**PRIMARY ROAD SYSTEM
FAYETTE COUNTY
BRIDGE REPLACEMENT**

IA 93 - Stream 0.7 mi W of Co Rd V68

FIELD EXAM MARK-UP

Field Exam held virtually on 6/14/21

DESIGN FOR 15° SKEW L.A.
TWIN 12'-0x11'-0x90'-0 CAST IN PLACE CONCRETE CULVERT
 SITUATION PLAN
 STATION 69+73.85 JUNE 2021
 FAYETTE COUNTY
 IOWA DEPARTMENT OF TRANSPORTATION - HIGHWAY DIVISION
 DESIGN SHEET NO. 1 OF 1 FILE NO. 31934 DESIGN NO. 124

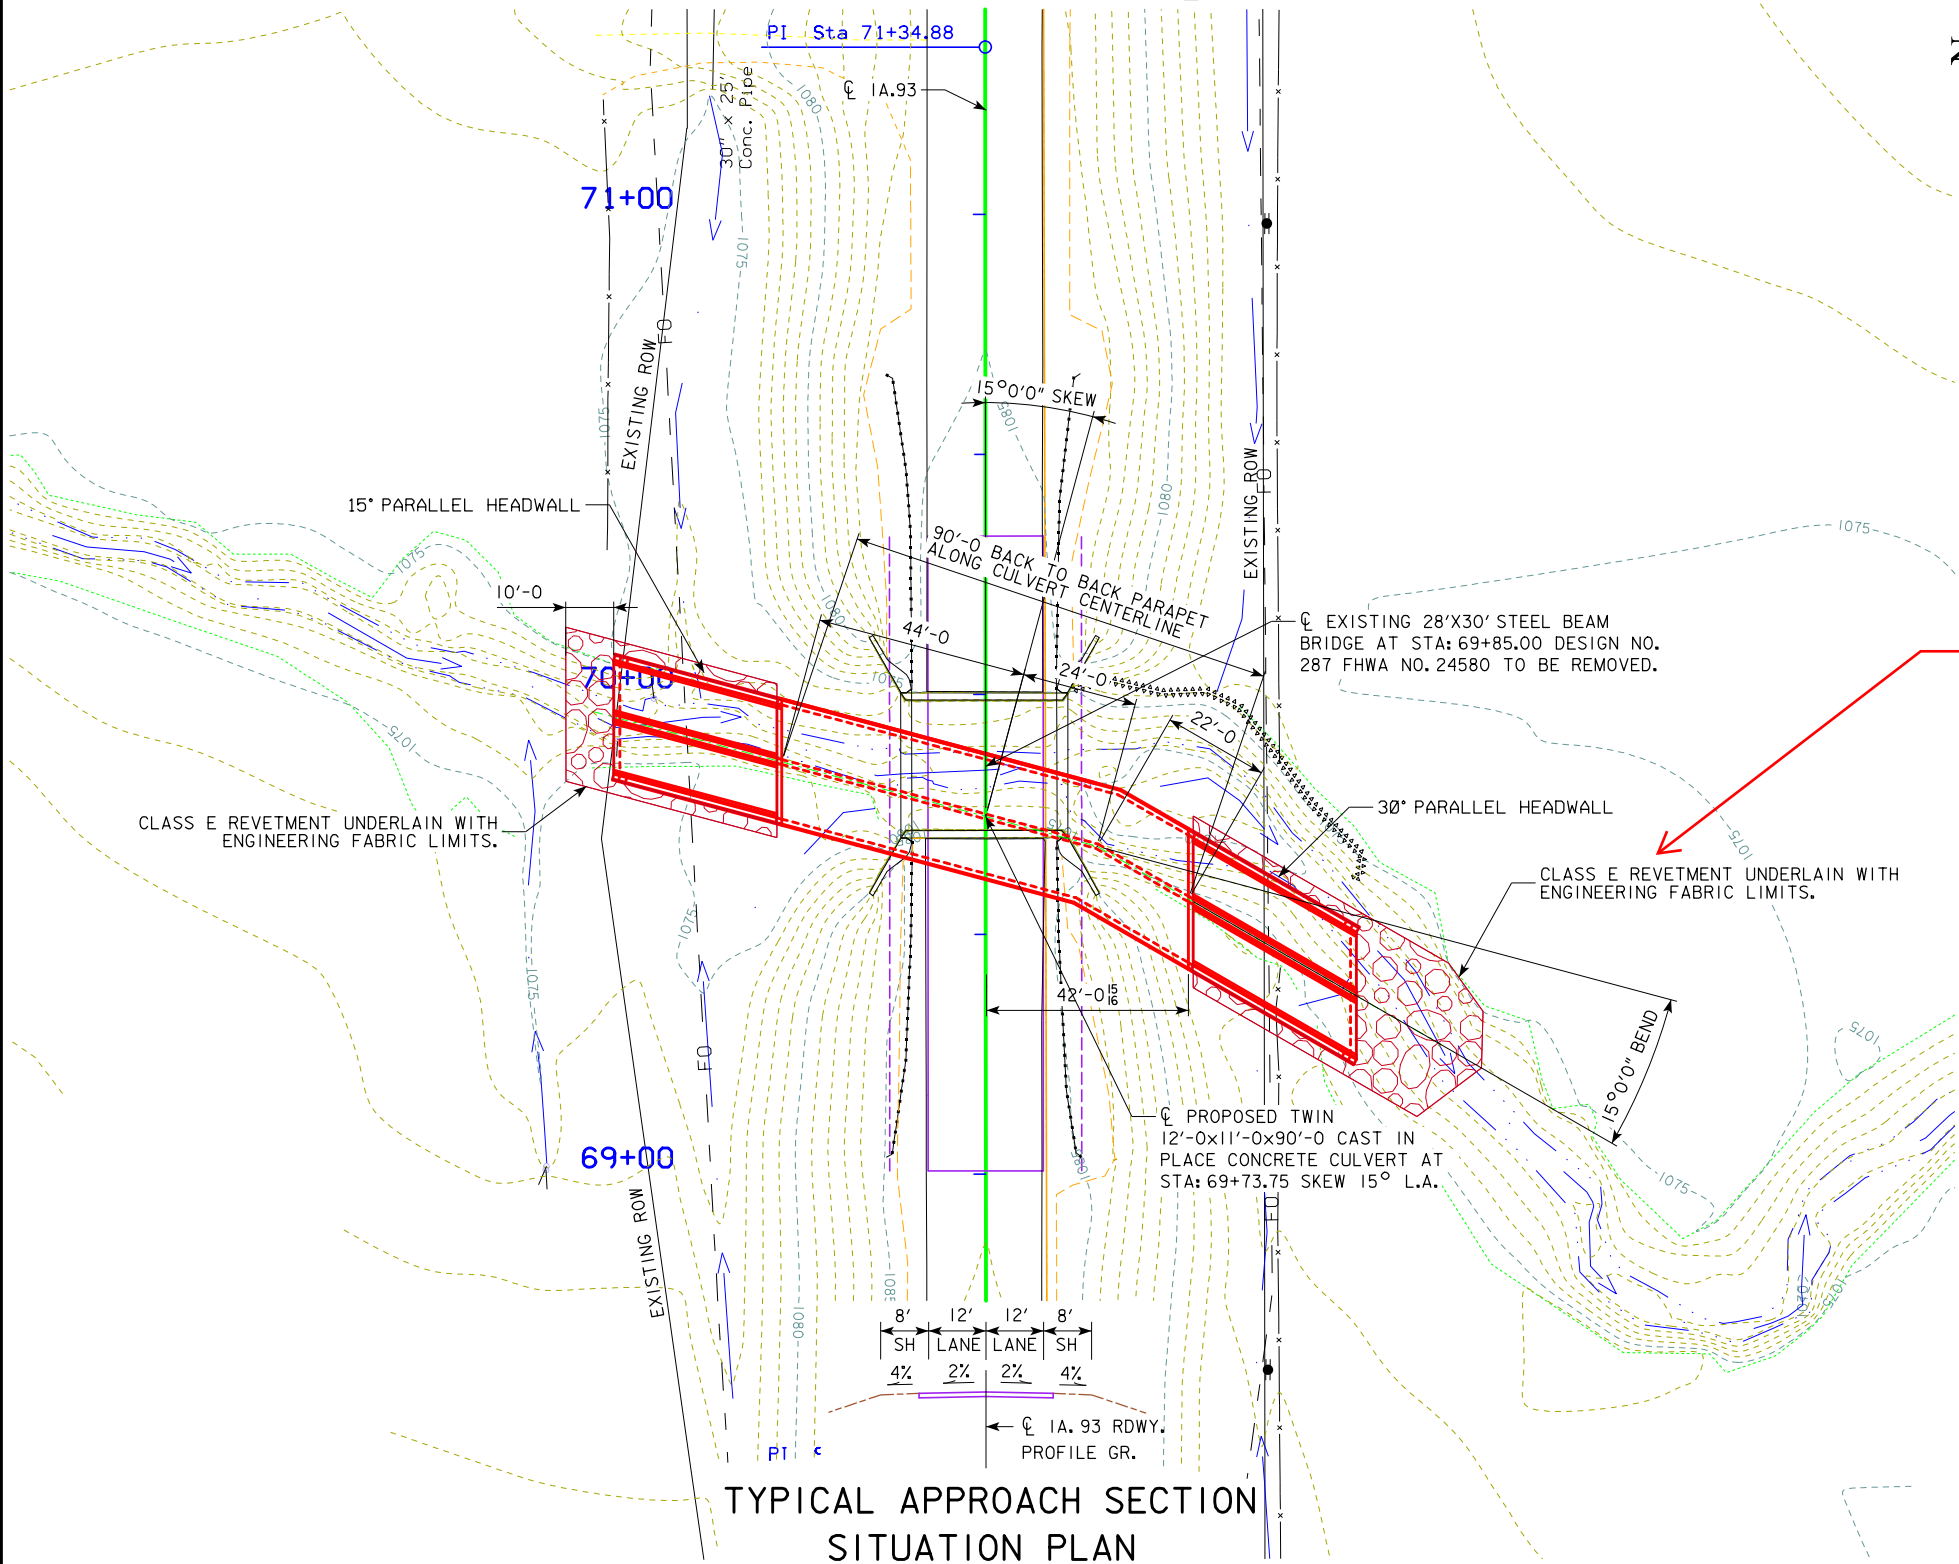
Use Class B
Revetment due to
high flow velocities
